# INITIAL FIRE SAFETY INSPECTION REPORT

## Topway Industries Limited

**Date: 27-09-2023**

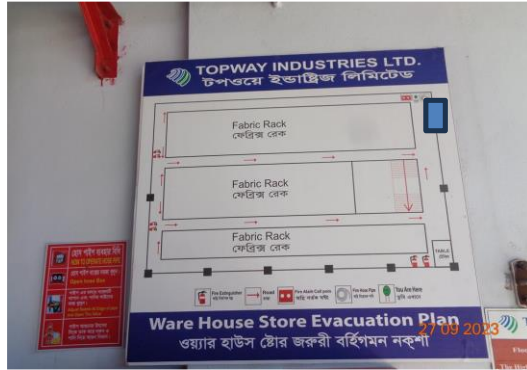
SI No.	Category	Findings	Required Action	Remediation Time Frame
F-13	Fire Rated Construction	The building is made of steel and found exposed without any fire protection which is defined as non-rated construction and a violation of BNBC-2006. Location: Building - 03	<p>Construction must be of type 1 or type 2 (See BNBC 2006 Part 3 Table 3.2.4, page 10356 and Part 3, Table 3.1.9, page 10319).</p> <p>Provide/ensure required fire rating on the structural elements by following Section 4.4 and Table 4.4.1 of the RSC Technical Guideline (standard) V1 or Table 3.3.1 and Table 4.1.1 from BNBC 2006. Consult a qualified fire protection engineer to design the rated construction barriers.</p>	Within 6 months
<div style="display: flex; justify-content: space-around;">   </div>
